Con Edison
Consolidated Edison Company of New York, Inc.
Indian Point Station
Broadway & Bleakley Avenue
Buchanan, New York 10511-1099

Re: Indian Point Unit No. 2
Docket No. 50-247

Subject : Response to Request for Additional Information - Generic Letter 97-04, "Assurance of Sufficient Net Positive Suction Head for Emergency Core Cooling and Containment Heat Removal Pumps," for Indian Point Unit No. 2. (TAC No. M99999)

RESPONSE TO REQUEST FOR ADDITIONAL INFORMATION REGARDING RESPONSE TO GENERIC LETTER 97-04, "ASSURANCE OF SUFFICIENT NET POSITIVE SUCTION HEAD FOR EMERGENCY CORE COOLING AND CONTAINMENT HEAT REMOVAL PUMPS."

ATTACHMENT 1

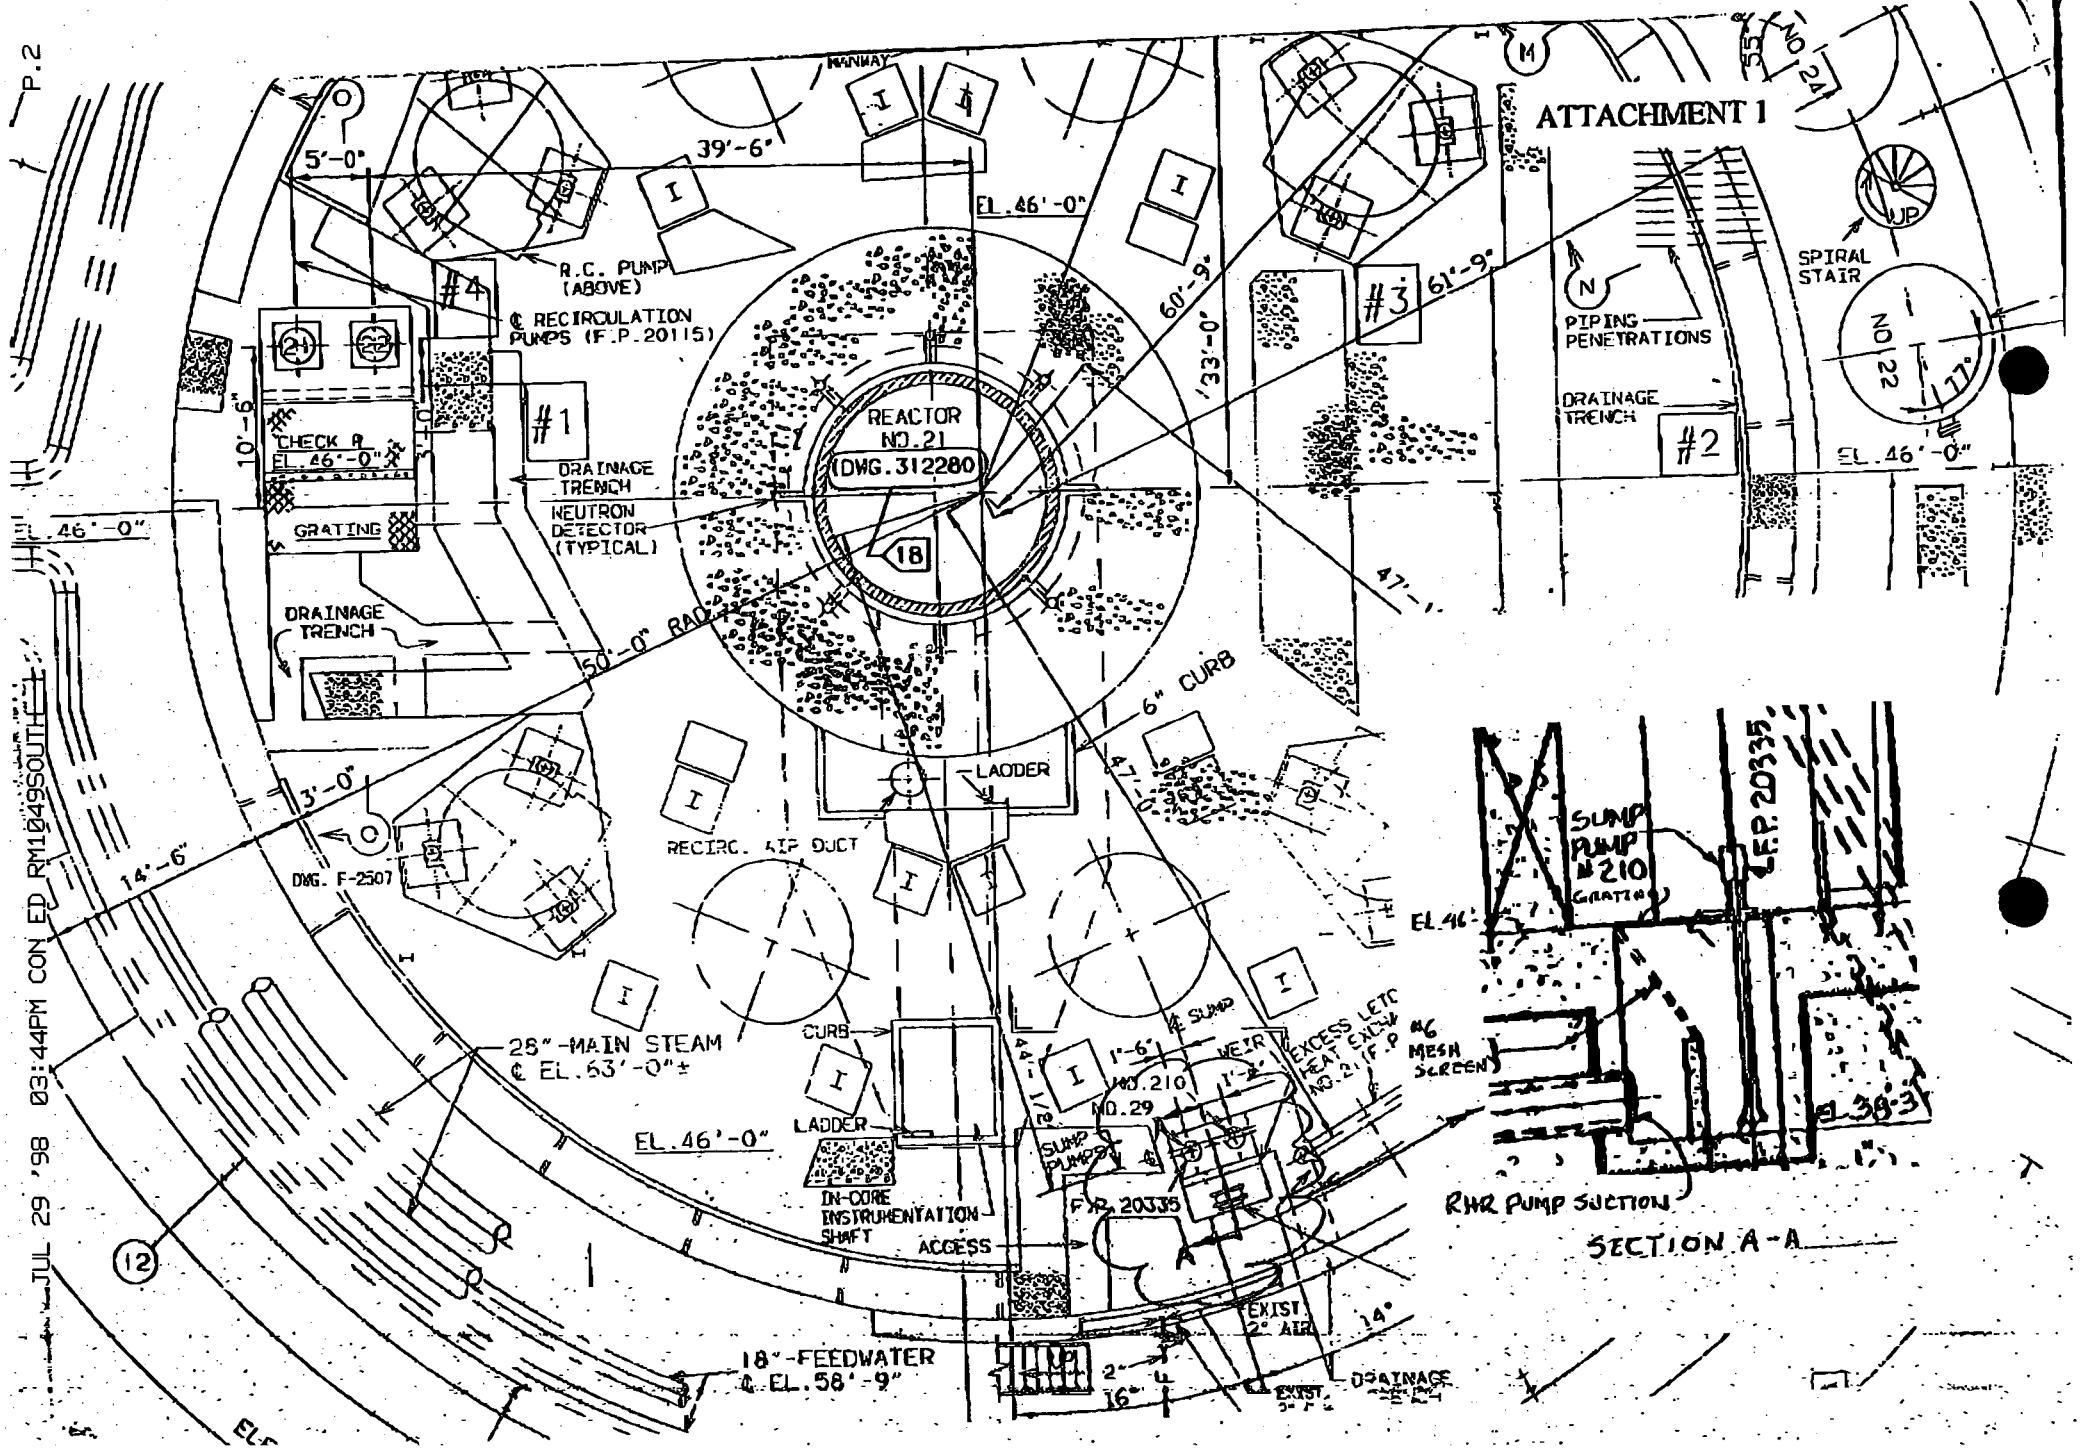
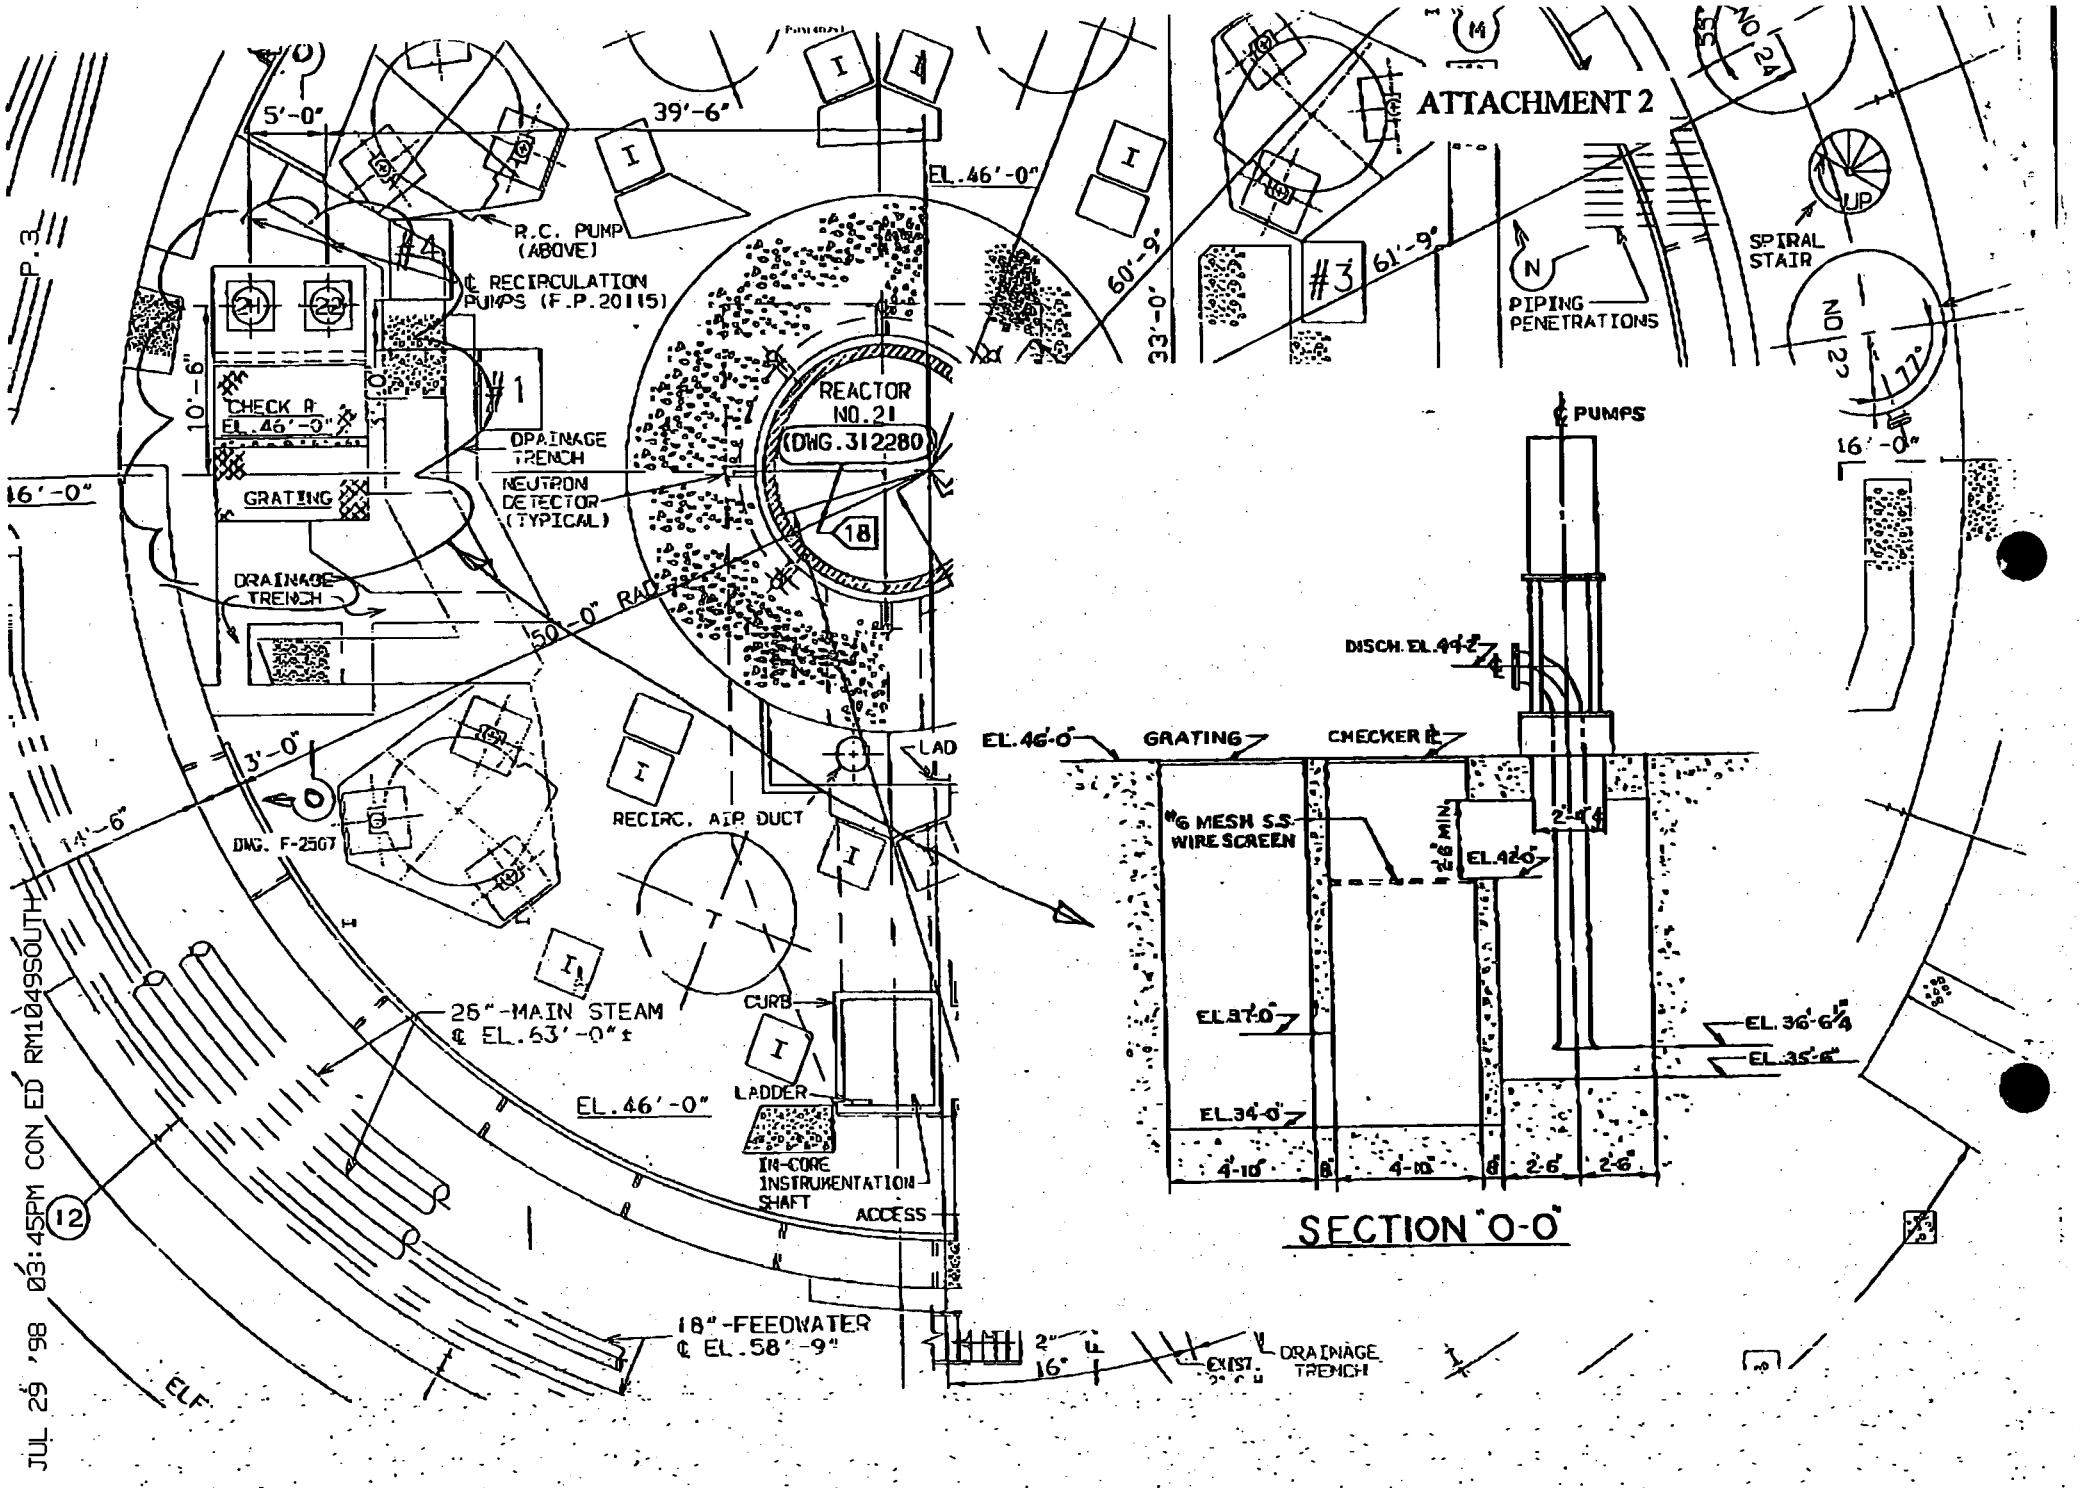
Residual Heat Removal (RHR) Pumps - The RHR System Pumps can be used for post-LOCA recirculation in the event that the Internal Recirculation pumps are not available. Should the RHR System pumps be used for post-LOCA recirculation operation, the RHR Pumps take suction from the Containment Sump (located about 90 degrees counter-clockwise from the Recirculation Sump). The sump fluid is cooled as it passes through the RHR heat exchanger(s), and discharged to the RCS. The available NPSH is determined by the elevation difference between the containment water level and the centerline of the pump, less the friction losses in the pump suction line and the sump. The sump loss was determined assuming that the entrance grates are fully blocked. Flow to the sumps is via the trenches that lead into the sumps. Although, in the determination of the available NPSH, the sump grates are assumed 100% blocked and screens are assumed to be 50% blocked, blockage of the entrance grates and sump screen is highly improbable because of the location of sump and the sump entrance.

The Containment Sump is located inside the crane wall but it is physically separated from the Recirculation Sump, which is located on the south-southeast side of the Containment (see attachment 1). It is a 7'-8" deep labyrinth pit set in the Containment floor. Within this sump is the piping that penetrates the Containment to supply the RHR Pumps. The top of this sump is set flush with the floor at El. 46'-0" and is covered with 1" x 4" floor grating that serves as the grating screen. Water enters the Containment Sump area via several possible flow paths inside the crane wall. There is also a labyrinth passageway into the sump area through the crane wall on its south side.

The Containment Sump is fed by a trench that runs around the eastern exterior of the crane wall for approximately 195°. This trench is covered with 1" x 4" floor grating that serves as the coarse screen. This grating is set flush with the floor in the annular space between the crane wall and the Containment liner

All water that enters the Containment Sump must pass through the grating. The arrangement of the coarse grates and the labyrinth sump enclosure makes the likelihood of debris entering the sump very difficult.
